# Evaluating Claims in the ACT/TDD Comparison: Corrections, Clarifications, and Evidence

Contribution to 802.3dm Task Force  
September 25, 2025

This presentation points out some of the errors in the presentation “ACT and TDD Comparison”, by Claude Gauthier and Frank Wang

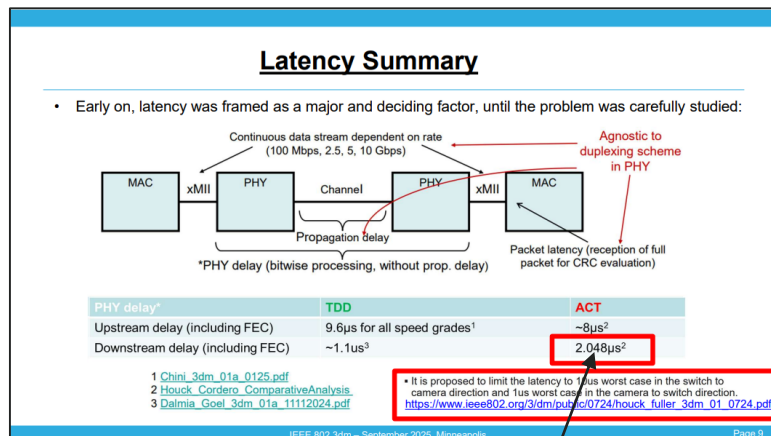
1. The 2.048μsec referenced is from 802.3ch specification
2. Please clarify how TDD can be faster latency than ACT with Quite Period and Refresh Period. See the ACT latency numbers for DS and US [Slides 20–21, 31.]

This was an assumed 802.3ch number for 10Gbps  
[langner 3ch\\_01a\\_0918.pdf](#)

**TDD Upstream :**  
 2.5Gbps = 1.304μs  
 5.0Gbps = 1.118μs  
 10Gbps = 1.026μs

**ACT Upstream:**  
 2.5Gbps = 1.4μs  
 5.0Gbps = 0.7ns  
 10Gbps = 351ns

**ACT & TDD DS :**  
 ACT = 2.82μs  
 TDD = 9.571μs

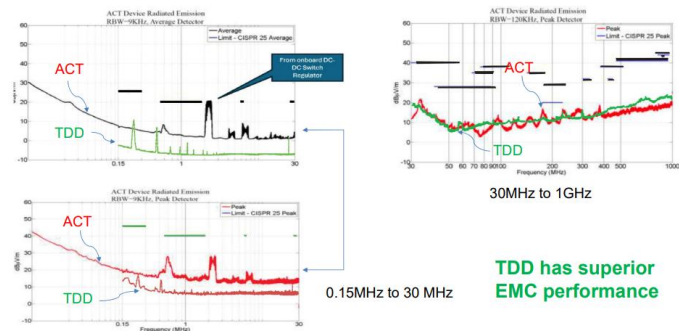
**Misleading:** What was timing, bandwidth, and frequencies for DL/UL tested?

Is this TDD or ASA?

If the above differs ASA is not TDD as specified [Evolution of 802.3dm: From GMSLE to ACT and Beyond](#)

Review **Slide 9** – TDD is Time driven ASA is Protocol driven

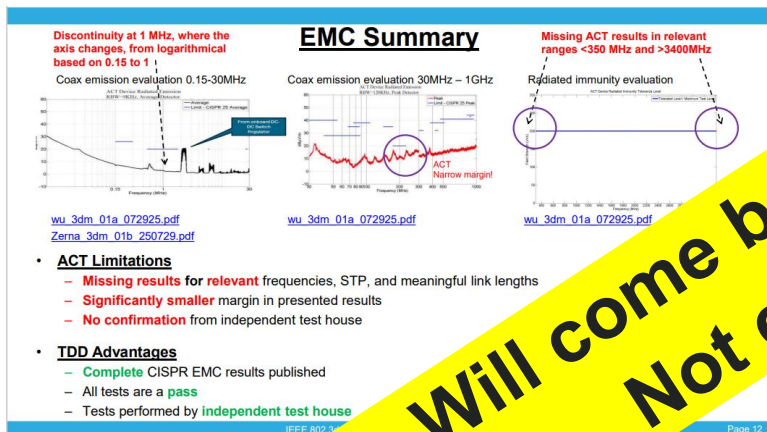
**Misleading:** Is this TDD or ASA? Please specify exact timing

**Misleading:** ACT tested Crystal-less and PoC – TDD did not

Review **Slide 3**

**Incorrect:** to compare the noise floor (where there are no peaks) between different CISPR25 measurements.

The noise floor depends on the equipment used in the test (LNA noise figure, spectrum analyzer type), independent of the modulation type.

**Misleading:** Radiated emissions is very dependent on board and cable type.

It is not valid to compare different test setups for relative performance.

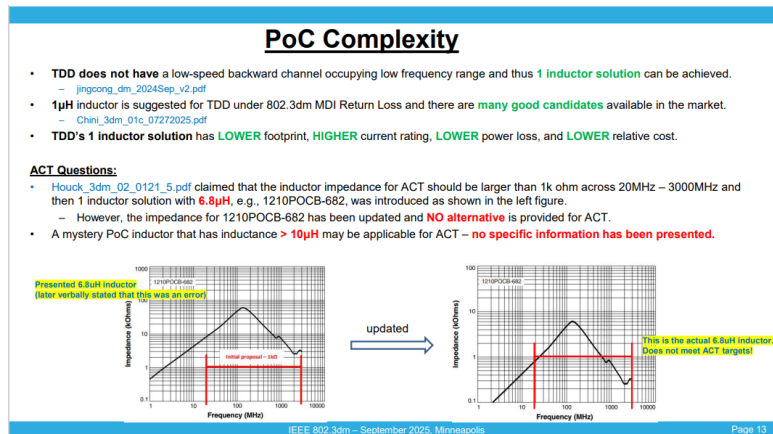
**Misleading:** Does the 1uH TDD 1 inductor solution work with EMC and 15 meters with 4 in-line cables?

**Incorrect:** Return Loss does not prove a valid solution

**Incorrect:** TDD requires impedance – no discussion – review impedance presentation again and comparison presentation on why this is critical

No discussion of **slide 19** on TDD, higher bandwidth than ACT and low frequency baseline wander issues

Baseline wander issues for TDD (Low frequency)

Why Impedance Matters – review full presentation and explain why TDD does not require impedance when Low frequency content is present

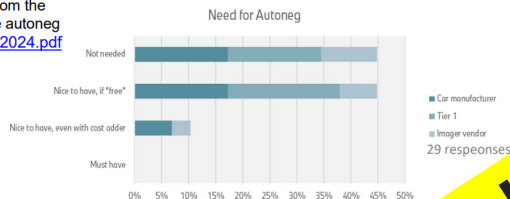
**Incorrect:** Differential Manchester Encoded (DME) modulation is a mature and robust method which has been used for decades in communications

**Incorrect:** Clause 98 is an optional part of the ACT proposal and has nothing to do with ACT crystal-less operation

**Incorrect:** Incoming signal does not have better jitter properties than a DME ACT signal with proper timing recovery.

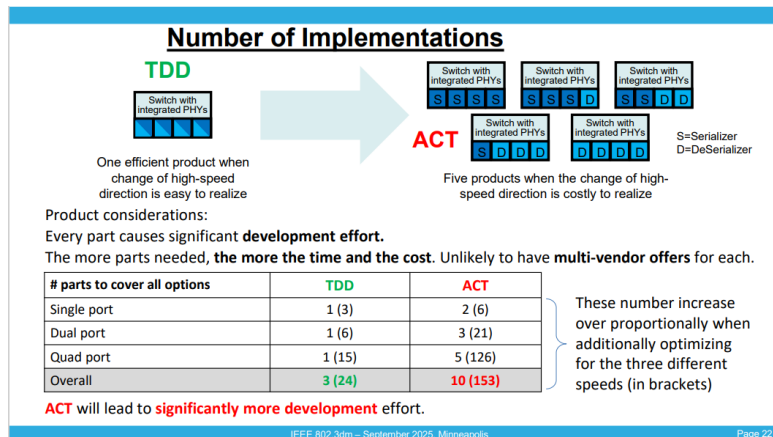
**Incorrect:** TSN is not required for ACT.

**Incorrect:** ACT GPIOs are fast-acting, as stated last September (Hamburg) , and were the reason ASA-MLE did not move forward. TDD is now proposed due to latency issues.

Review the entire presentation for the history of latency in 802.3dm:
